November 29, 2016

Re: Comments on Draft Programmatic Environmental Impact Statement for Geological & Geophysical Activities on Gulf of Mexico Outer Continental Shelf

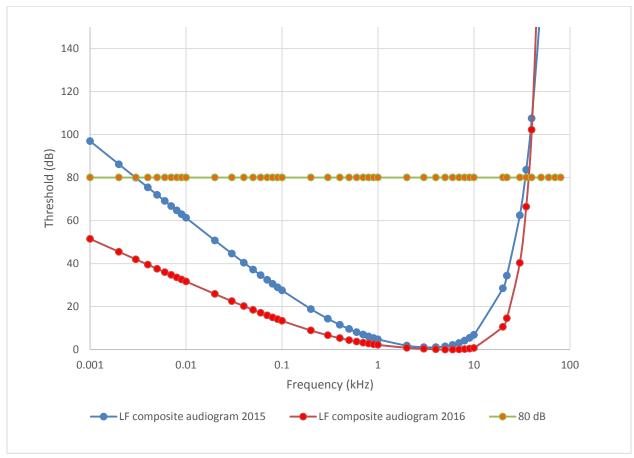
Figure 1. The consequence of the proposed changes to the LF cetacean modeled audiogram (in red) produce a hearing curve at the lowest frequencies that never approaches the 80 dB decrement from best hearing (in green) that NOAA had set as the upper and lower limiting frequencies of hearing (also a general mammalian metric of upper and lower hearing limits). The July 2015 modeled hearing curve (in blue), on the other hand, produces a crossing point with the 80 dB threshold at 3 Hz that provides a reasonable if generous lower limit of hearing.

In addition, on page 7 of the 2016 proposed changes, NOAA reviews four models for frequencies of best hearing and states that these models predict "thresholds within ~40 dB of best sensitivity as low as ~30 Hz and up to 25 kHz." However, rather than use the predictions of these models, NOAA proposes a curve that predicts LF cetaceans can hear 30 Hz at 10 dB above best hearing, not 40 dB. Under NOAA's model, whales could even hear sound at 10 Hz with only a 25 dB decrement from best hearing—which the best available science for baleen whale hearing modeling (*e.g.*, Houser et al. 2001; Cranford and Krysl 2015) and general mammalian hearing data strongly suggests is impossible. *See infra* footnote 8.

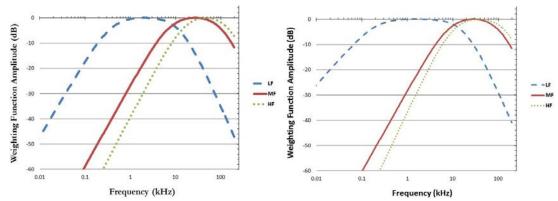
The impact of the new LF cetacean parameters is immediately obvious in our Figure 2 below, which compares Figure PC3<sup>7</sup> of the new 2016 criteria (*see right plot below*) with the curve depicted in NOAA 2015 Draft Guidance (page 12) (*see left plot below*). In contrast to the similar shapes of all the 2015 weighting functions, the new LF cetacean curve produces a biologically unrealistic, extended, and flattened curve.

Figure 2. The left plot shows initial July 2015 cetacean weighting functions: LF in dashed blue, MF cetacean in red and HF cetacean in dotted black. While the frequency range of best hearing for LF cetaceans is conservatively generous given uncertainties in the models, the slope of the weighting functions are all parallel, consistent with what is generally observed across mammalian hearing and weighting functions. The right plot shows that the modified March 2016 weighting functions not only create a much broader and obviously unrealistic span of best hearing (the flat upper part of the curve normalized to zero), but also provide a slope of increased weighting (decreased hearing ability) at the lower frequencies that is clearly out of alignment with the measured decrement of hearing acuity in all other marine mammals, as well as for mammals in general, including other LF specialist species.

NOAA's proposed LF cetacean model also sharply deviates from data pertinent to other LF specialist mammals. For example, humans are LF hearing specialists that have a best hearing range of approximately 400 Hz to 16 kHz. But, unlike the LF cetacean model proposed by NOAA, human hearing ability is 25 dB below best hearing at 200 Hz—not the 10 Hz value generated by NOAA's proposed hearing curve. As another example, the kangaroo rat (another LF hearing specialist) has best hearing that starts to diminish at approximately 500 Hz. By 100 Hz, the kangaroo rat's hearing threshold is at least 10 dB above best hearing, and at 20-30 Hz is
